DEVELOPMENT ASSESSMENT REPORT			
Application No.	DA/2021/0433		
Address	27 Junction Road SUMMER HILL NSW 2130		
Proposal	Alterations and additions to an existing dual occupancy including attic addition, rear extension, new pools and strata subdivision		
Date of Lodgement	02 June 2021		
Applicant	Mr Saxon Grujovic		
Owner	Mr Dylan K Gruhovic Mr Saxon P Grujovic Mr Sami Virsunen		
Number of Submissions	Initial: Two (2)		
Value of works	\$355,000.00		
Reason for determination at Planning Panel	FSR and height variation exceeds 10%		
Main Issues	Height, FSR, privacy impacts, impacts to trees and streetscape		
Recommendation	Approved with Conditions		
Attachment A	Recommended conditions of consent		
Attachment B	Plans of proposed development		
Attachment C	Clause 4.6 Exception to Development Standards

This report is an assessment of the application submitted to Council for alterations and additions to an existing dual occupancy including attic addition, rear extension, new pools and strata subdivision at 27 Junction Road Summer Hill.

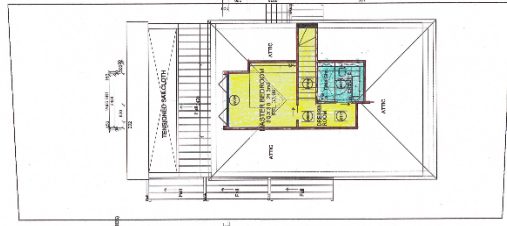
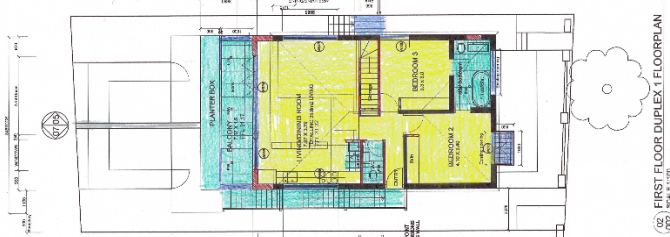
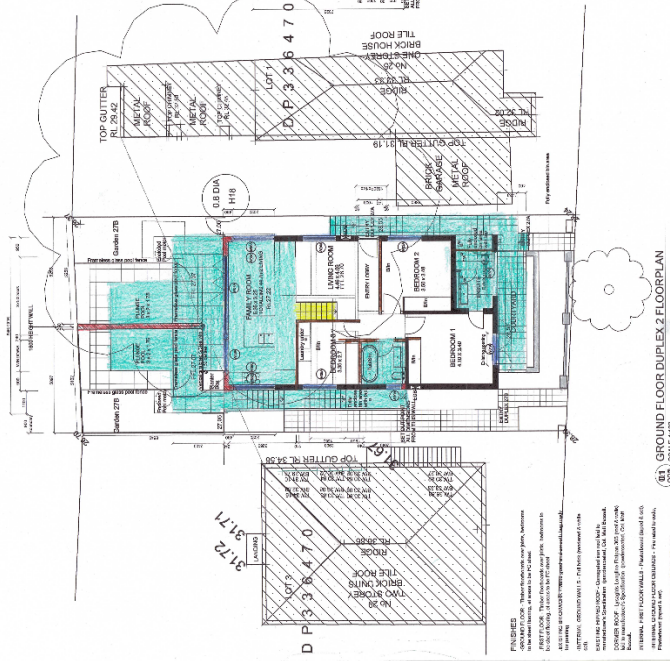
In response to Council's concerns the applicant has amended the rear elevation of this balcony to now include two (2), 1.2m wide privacy screens, extending the full height of the balcony opening. These screens are noted to be located on a movable track and can slide across the balcony opening. This privacy treatment ensures that future occupants can position the screens to avoid direct sightlines, while allowing them to be moved to ensure sufficient amenity to the unit. This treatment combined with the solid balustrade, planter box (at the edge of the balcony) and roughly 16m separation between the proposed balcony and neighbouring units at 19 Junction Road is adequate to ensure sufficient privacy for all neighbours and occupants.

A review of the proposed balcony dimensions has highlighted an inconsistency with the width, with the notation on the balcony saying 7.37x1.5m and the dimension on the edge saying 1.8m. In order to limit the intensity and subsequent potential acoustic impacts from this balcony, a design change condition limiting the trafficable width of the structure to 1.5m is included in the recommendation of this report. This 1.5m trafficable width ensures that occupants have sufficient room to utilise the space as a secondary POS, but that the space cannot host large gatherings. Any such gathering could occur within the ground floor POS or internally to the unit.

- a. The proposed change of the existing tile roof to a colourbond roof is not approved, all notations of a colourbond roof are to be deleted. The roof must remain a tile roof. Replacement of any damaged existing tiles permitted.
- b. The proposed balcony to bedroom 2 of the first floor unit facing Junction Road is not approved and is to be deleted. The existing window opening to bedroom 2 is not to be altered and is to remain in its current form
- c. The courtyard and retaining wall within the front setback to Junction Road accessed from bedroom 1 of the ground floor unit is not approved and is to be deleted. The existing window opening to bedroom 1 is not to be altered and is to remain in its current form
- d. The proposed in-ground swimming pools located within the rear yard are not approved and must be deleted. Both swimming pools must be deleted from any future plans.
